Certification Labels – Incorrect Rear Tire Information

Bulletin Type:	TSB	Publication Date:	February 2026
Bulletin #(s):	26-005	Make(s):	Jayco, Entegra Coach
Job Code(s):	9803647	Model(s):	Greyhawk XL, Accolade XT, Esteem XL
Flat Rate(s):	9803647 - 0.3 Hr. Labor - Replace Certification Label	Model Year(s):	2025 - 2026

Technical Service Bulletin Notification TSB #: 26-005

Certification Label

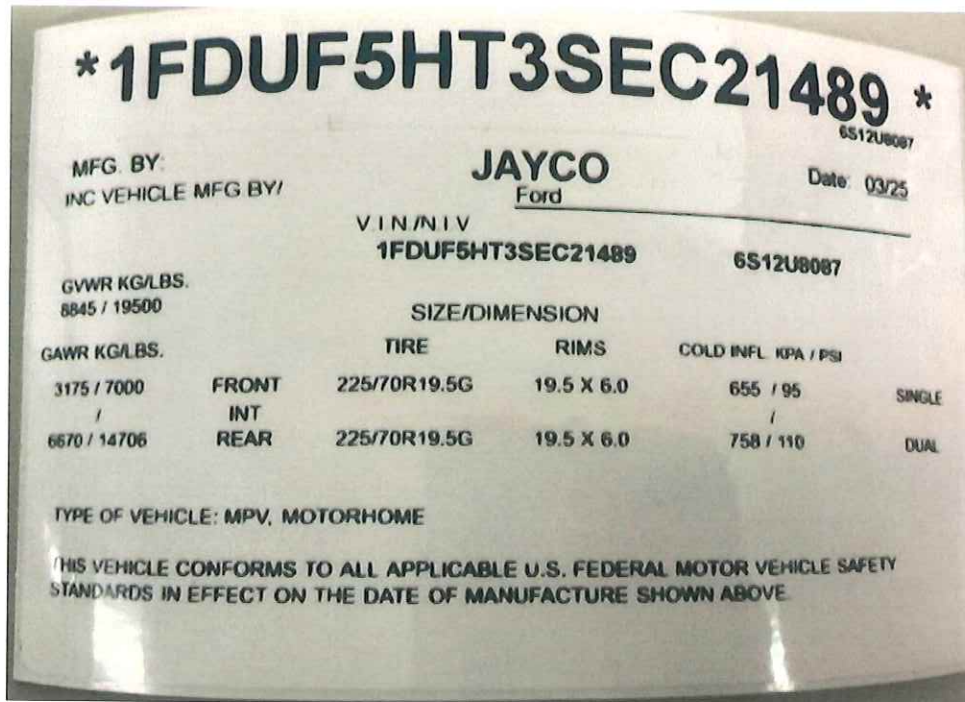
Incident:	Certification labels show rear tire inflation for chassis listed under the “Single” specification instead of “Dual” specification for the rear wheels.
Affected Units:	2026 Jayco Greyhawk XL; 2025 – 2026 Entegra Coach Accolade XT, Esteem XL
Part:	Part: Certification Label enclosed in owner/dealer notification letter
Misc. Tools & Supplies:	Isopropyl alcohol Shop rag
Parts Return Information:	N/A

The certification label below is only an example of the label you are to replace.

1. Class C Models the certification label will be affixed on the Driver side door B’ pillar (door latch post pillar).
2. Remove the existing label. Using isopropyl alcohol and a shop rag, remove any adhesive residue from the surface where the original label was removed.
 - a. Allow the area to dry for at least 30 seconds.

1. Remove the protective back from the new label. Align the new label in the same location of the original label and apply it to the surface. Remove any air bubbles from the label.
 - a. **Note:** Do not attempt to remove or adjust the label once it has touched the surface. Doing so may damage the label or cause it not to adhere properly to the surface.
